HEATHROW NCP PROPERTY LTD
PROPOSED ACCESS ARRANGEMENT
NCP CAR PARK, A4 BATH ROAD,
HEATHROW

STAGE 1 - ROAD SAFETY AUDIT

Stage 1 Road Safety Audit

Ref: S/NCPHeathrow.1.6

Problem Locations

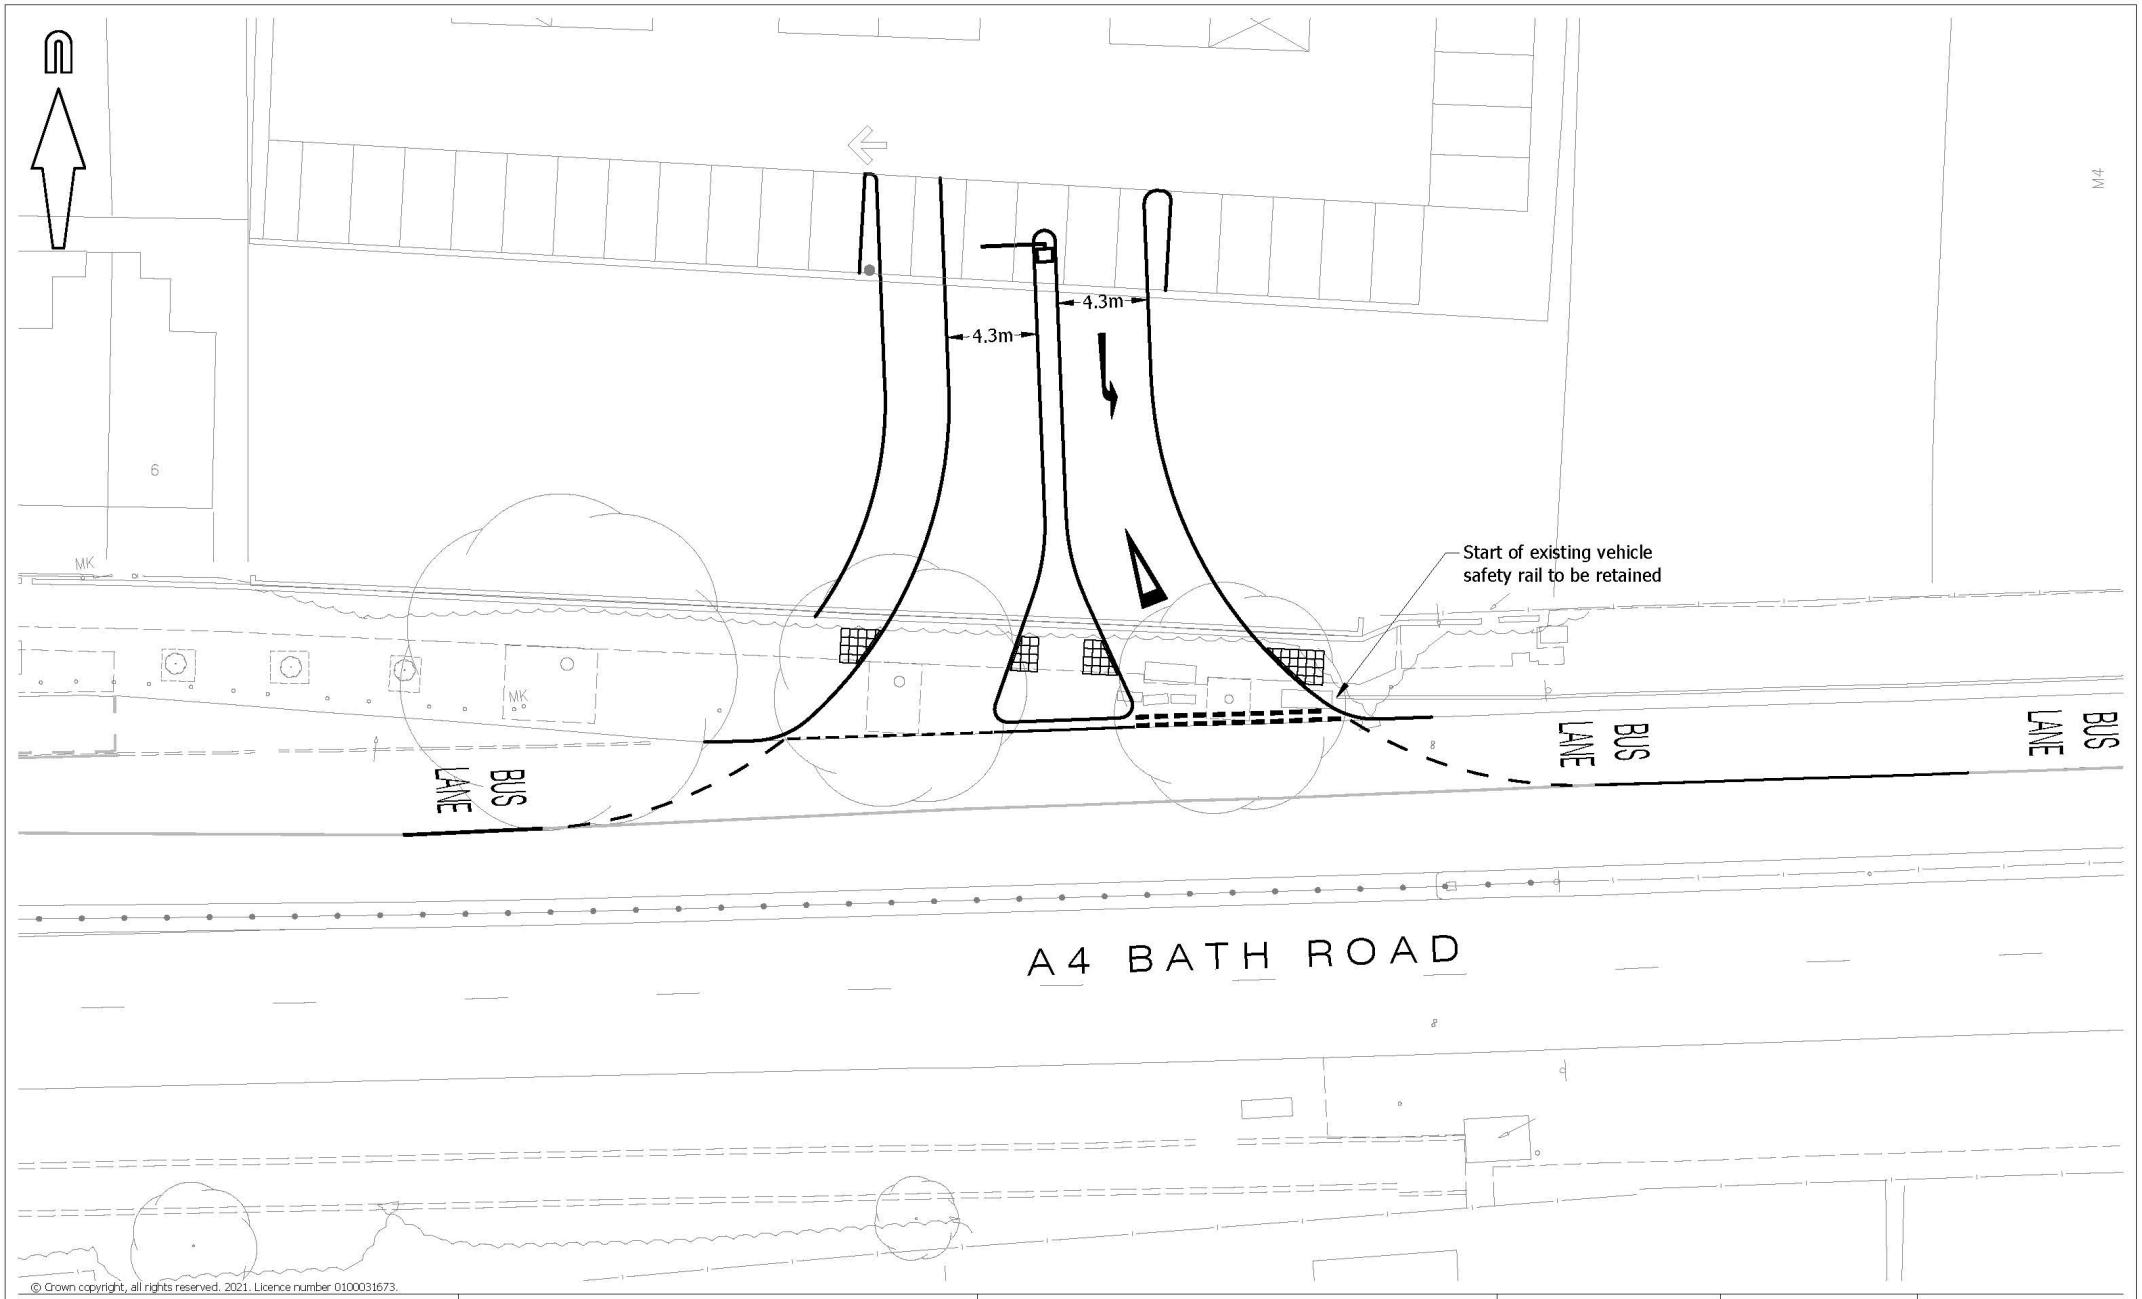
Location: Proposed car park access (please refer to reference point 3.1.1 in **Appendix B**).

Summary: Inconsistent use of tactile paving – NMU confusion.

DETR recommends that 'in-line' tactile paving should be 1200mm deep across the full width of the dropped kerb, this is to ensure that necessary warning is provided to a vision impaired pedestrian proceeding at normal pace.

However, the tactile paving provided is 800mm deep when measured back from the channel line, which could lead to a vision impaired pedestrian stepping over the tactile paving and entering the carriageway unaware, with consequent risk of being struck by a moving vehicle.

It is recommended that that tactile paving is provided in accordance with DETR 'Guidance on the use of tactile paving surfaces'.
